**Colt Industries**

**Fairbanks Morse  
Engine Division**  
701 Lawton Avenue  
Beloit, Wisconsin 53511  
608/364-4411

Subject: Colt Industries-Fairbanks Morse Engine Division  
Colt PC-2 Series Emergency Diesel Generators  
Potential Overspeed Trip  
Part 21 Report

Enclosure: 1) Colt's Diagram of Rack Boost  
Cylinder Control Connections

DIAGRAM OF RACK BOOST CYLINDER CONTROL CONNECTIONS

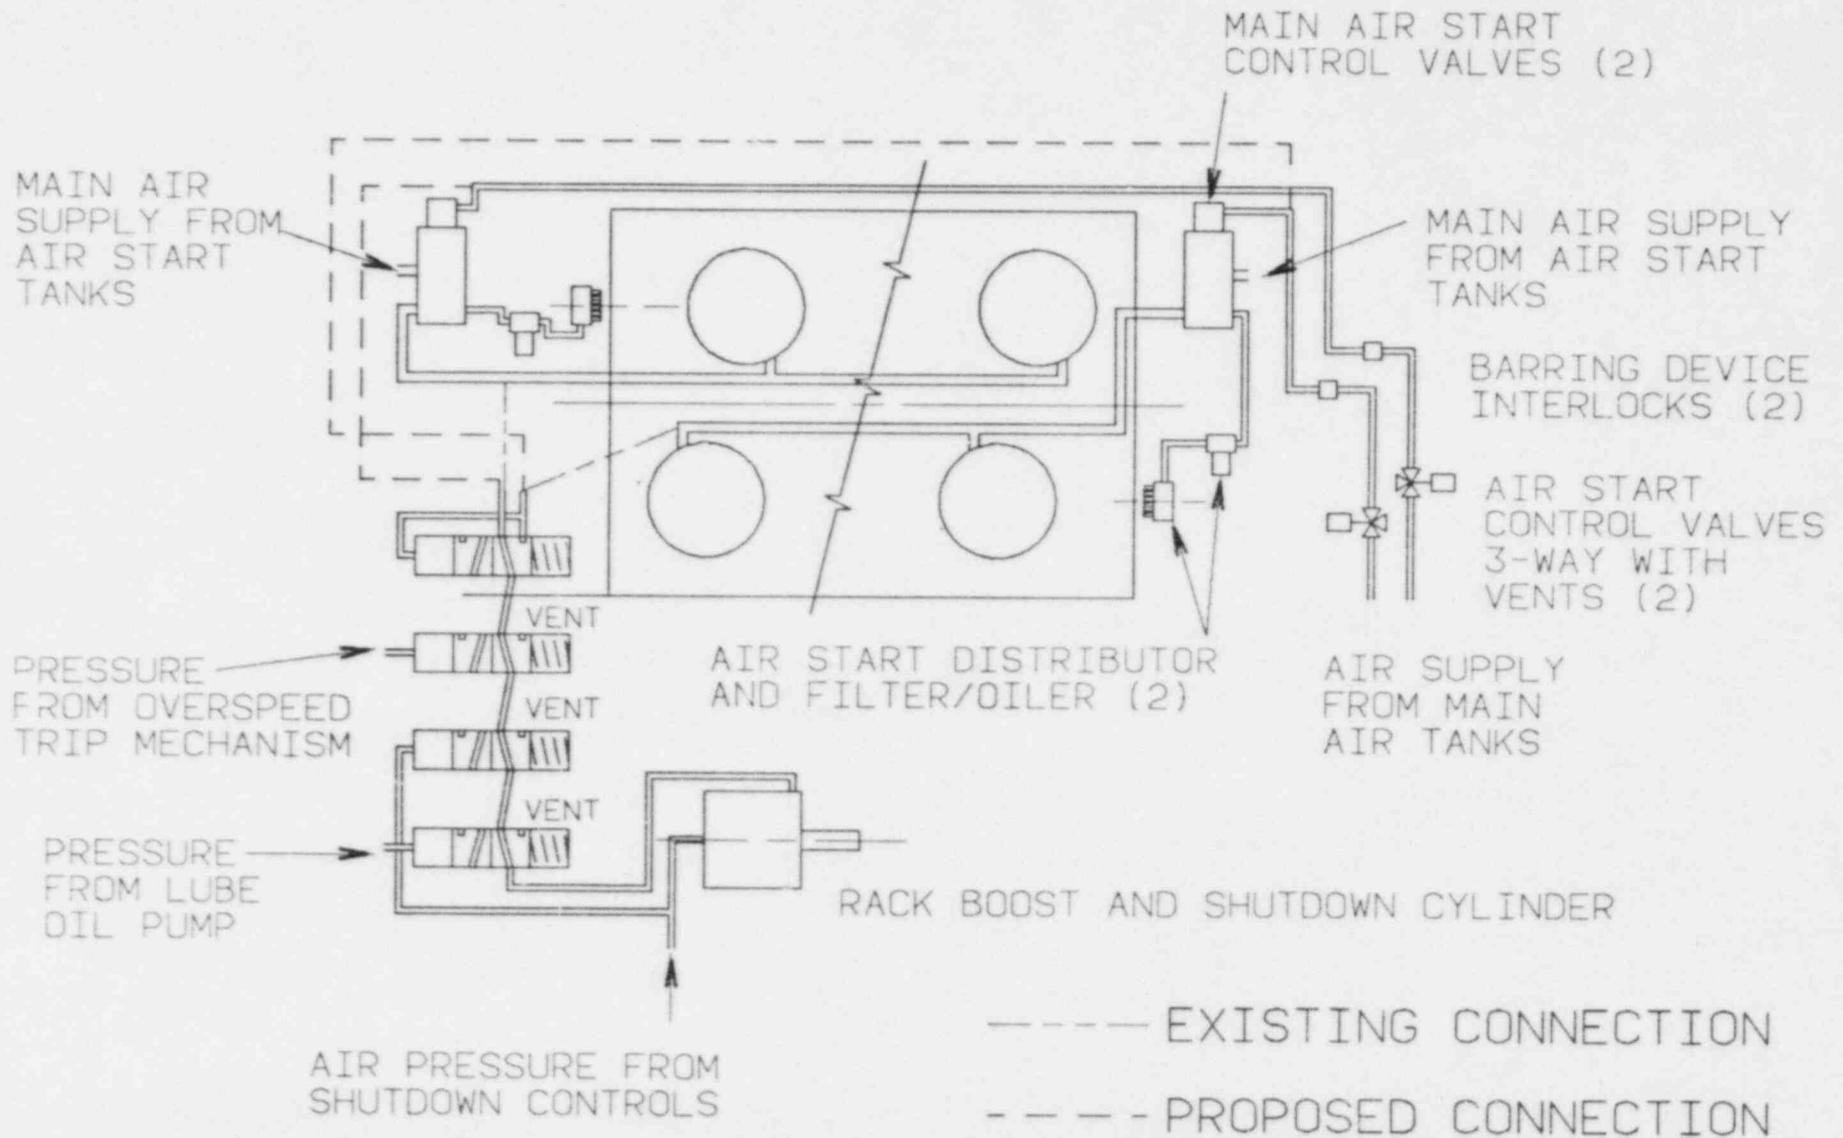
An overspeed trip on startup has been reported to Colt by Public Service of New Hampshire, Seabrook Nuclear Plant, Unit 1B. Reports from the site indicate the starting air pressure, which actuates the governor rack boost, was not being vented from the rack boost promptly after the start signal had been terminated, causing the boost to fight the governor. Examination of the piping schematics confirmed this could happen, an alternate piping arrangement was suggested, and a field change was initiated. A Colt engineer was dispatched to observe tests confirming the validity of the change.

Site tests and engineering evaluation completed this date have confirmed the repiping as shown on the enclosure removes the potential problem. The potential problem is limited to PC-2 Series of engines (this report does not apply to 38TD8-1/8 engines).

To prevent any further occurrences, or the possibility of same, Colt Industries is recommending that all Colt-Pielstick engines in nuclear service be modified to positively vent the air from the rack boost cylinder, and its associated shuttle valves, by making the source of that air supply from the pilot air lines that control the main air start admission valves. The pilot air lines are controlled by solenoid valves that receive the start signal from the control system. These are three way valves which positively vent the pilot signal to atmosphere when the control system senses that the engine is started.

The modification of the system consists of removing the rack boost shuttle valve connections to the main air start headers, and making those connections to the pilot air lines, at the point where the pilot air lines connects to the pilot connection on the main air start valves. This reconnection is shown schematically on the enclosed figure.

A copy of this report and enclosure 1 is being forwarded to the Utilities involved by registered mail. The modification involves only minor tubing changes which should be implemented by each utility at their sites.
